SUMMARY OF CONCERNS IN RELATION TO THE PROPOSED NORTHCONNEX TUNNEL

This is an objection to many aspects of the proposed NorthConnex tunnel.

MOTORWAY OPERATIONS COMPLEX - SOUTHERN VENTILATION FACILITY - SECTIONS
M1-M2-5000-DR-JD-0525

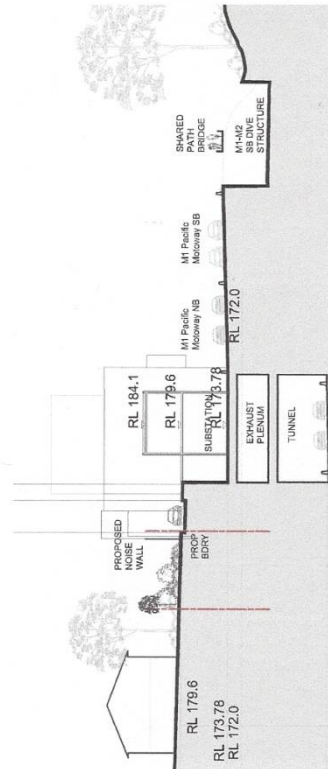
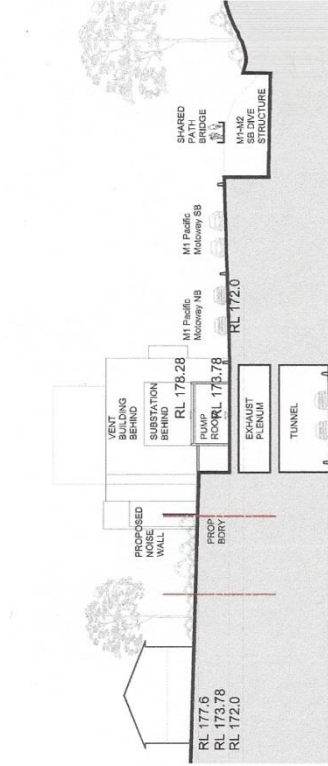
5. *EIS Volume 4, Technical working papers - Urban Design, 6.0 Operational Ancillary Facilities*
EIS Page 99 there is the diagram "Motorway Operations Complex – Southern Ventilation Facility – sections. *Page 10 below* The diagram has the cryptic label "Connection to tunnel TBC". What does TBC stand for? To be considered? Why is tunnel singular? Which tunnel is the diagram referring to northbound or southbound? There is no diagram showing any connection from the Southern Interchange ventilation facility to either the northbound or the southbound tunnel in any way AND YET

- Diagrams need to be provided showing the inter-relation between the shaft, the ventilation outlet and the motorway operations centre with a clear description of what is to be constructed and how it will operate.
- The community needs irrefutable evidence that the polluted air from the southbound tunnel exit portals will not be allowed to flow like an invisible sewer through West Pennant Hills, North Rocks, Carlingford and Beecroft.

M1-M2-5000-DR-UD-0550
NORTHERN VENTILATION FACILITY - CROSS SECTIONS

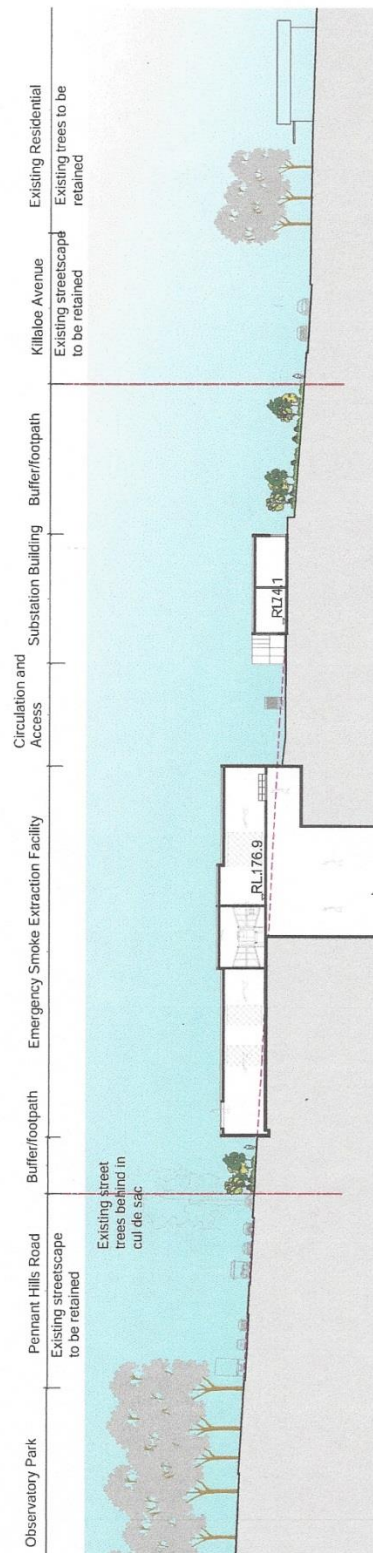
EIS page 135 *Page 11 below* there is a very explicit diagram showing the *Northern Ventilation Facility – cross section*.

EIS page 134 *Page 12 below* there is a very explicit diagram showing the *Northern Ventilation Facility – long section*.

Why are there no comparable diagrams for the Southern Interchange and the Southern Ventilation facility?
